# Memorandum

**Re: Final Minutes of the March 31, 2023, HCP Coordinating Committees Conference Call**

### A. 2023 Rocky Reach CSS SOA (Lance Keller)

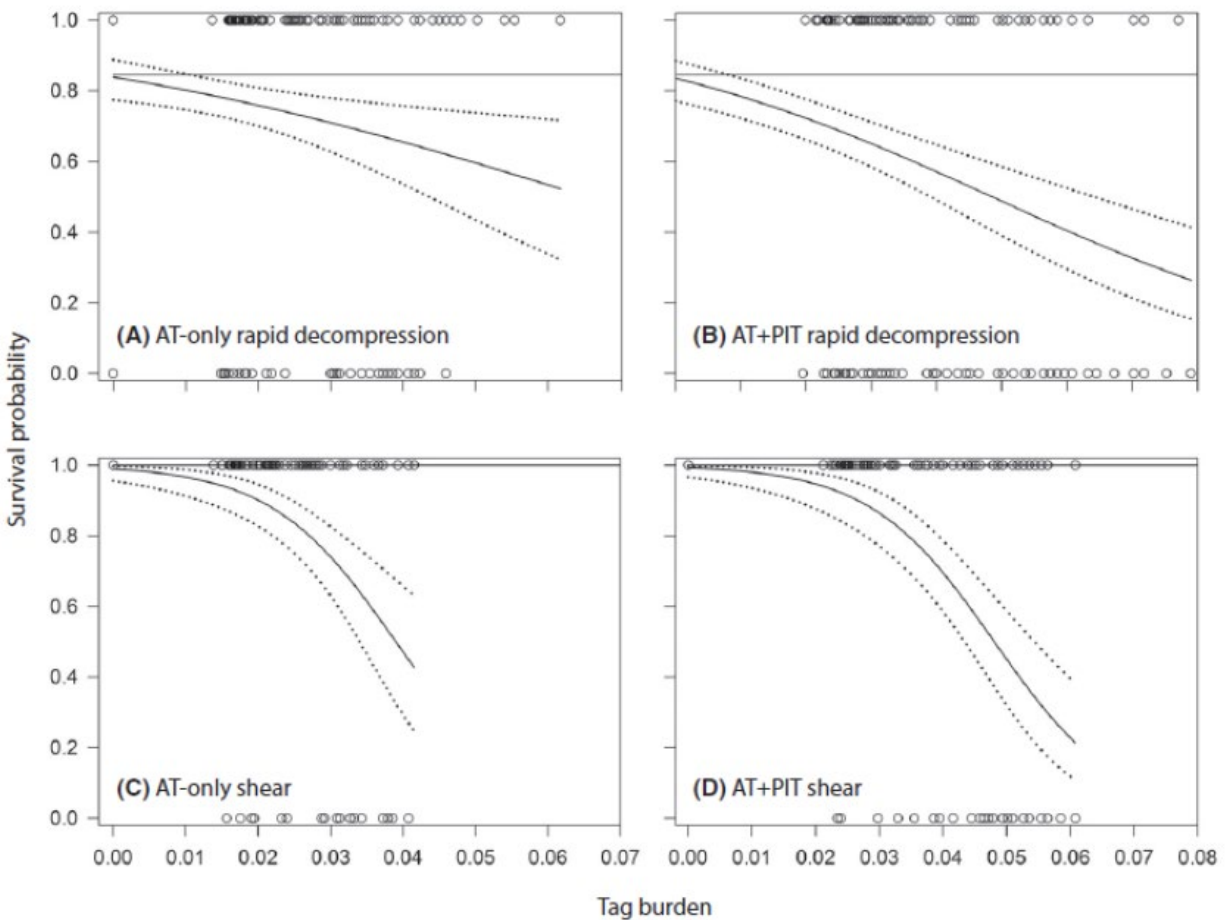
to use whichever metric yields the larger proportion of the run at large being included in the 2023 study. Regarding the literature, Chelan PUD is aware of PNNL's recommendation for 95 mm; however, the PNNL publications also mention that one should be cautious of tag burden, as an increase in tag burden results in an increase of mortal injury due to rapid decompression and shear forces. Further, the PNNL paper was studying dam passage survival (not project survival) that used a higher tag burden than Chelan PUD will accept. That study was designed to allow fish to fall out. That is, from release to where fish were included in the study (virtual release array location), there was time and distance to allow any effects that would result in fish mortality to fall out and not impact the estimate. Recall the Geist et al. (2018) panels shared during the HCP Coordinating Committees conference call on February 28, 2023 (copied below). The survival probability for 2% versus 3.5% tag burden was quite different for AT+PIT<sup>1</sup> for rapid decompression (Panel B) and shear forces (Panel D).
